The Design and Alignment of P2

Submitted by The
Conservancy Association to
Panel of PLW subcom, LegCo

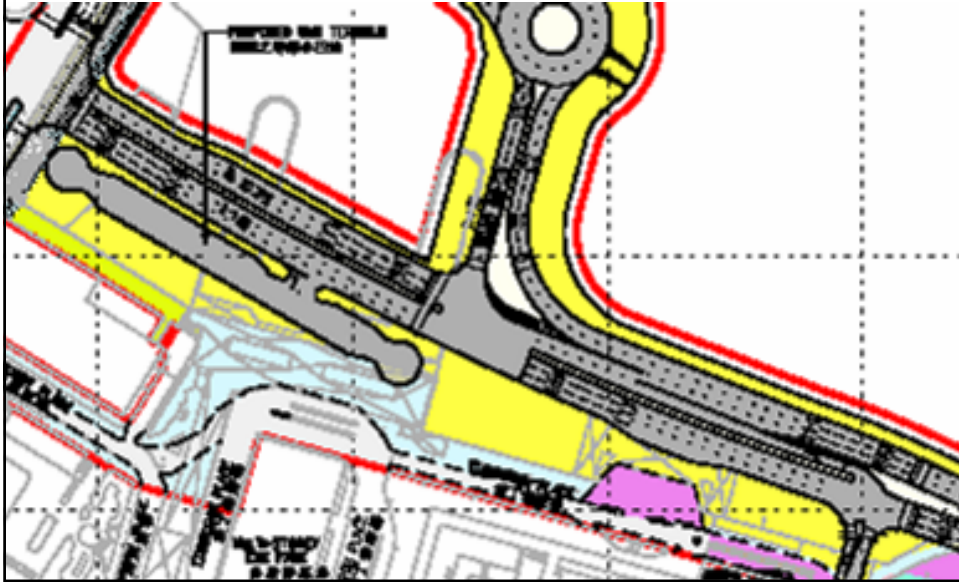
However, along the short section of concern (i.e., from Man Yiu Street to D7, there is also a P1 (2 x 2 lanes) from Man Yiu Street to D2 to share the traffic load. A total of 10 lanes (in 2 directions) in this short session to meet with this traffic demand (not to mention the future C&W Bypass) is too excessive. From D2 to D7, there are 6 to 8 lanes; it is again excessive.

The sections that pass through old star ferry pier and the existing Queen's Pier are 6 to 8 lanes which is much more than 2 x 2 lanes as specified in TD's paper. This section can certainly be narrowed down.

- There is no need to put a passing pocket in front of the City Hall which the existing Queen's Pier stands.

In brief, there are ample room to streamline the design of P2 road, in particular, at the concerned section. With these streamlining, it is possible to avoid colliding into the existing QP site.
